October 9, 1987

The Commission has issued the enclosed Amendment No. 28 to Facility Operating License No. NPF-30 for the Callaway Plant, Unit 1. This amendment is in response to your application dated March 31, 1987, as supplemented by letters dated April 15, June 5, June 18, July 16, July 28, August 7, August 13, August 31, September 9, and October 6, 1987.

The amendment modifies the technical specifications to support a transition from a Westinghouse 17 x 17 low-parasitic fuel assembly and optimized fuel assembly fueled core to a Westinghouse 17 x 17 Vantage 5 (V-5) fuel assembly fueled core.

Amendment No. 28
License No. NPF-30

FIGURE 2.1-1
 REACTOR CORE SAFETY LIMIT - FOUR LOOPS IN OPERATION

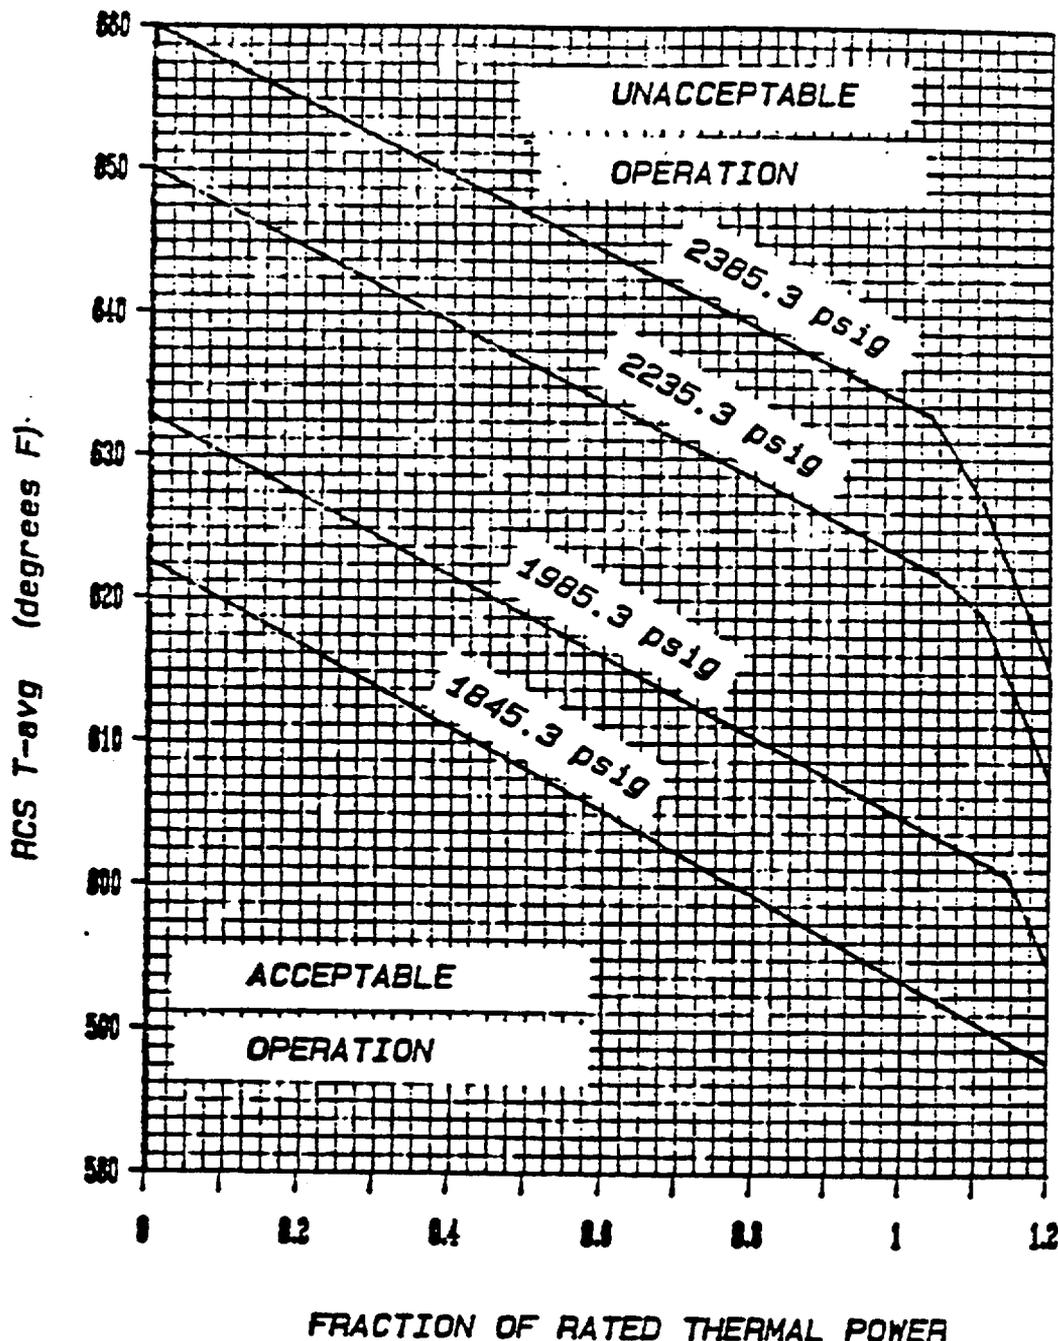
1. Figure 2.1-1. Revised Reactor Core Safety Limits. The new limits account for an increase in RCS core bypass flow due to V-5 fuel using the approved methodology described in WCAP-10444-P-A and WCAP-9272-P-A and are acceptable.
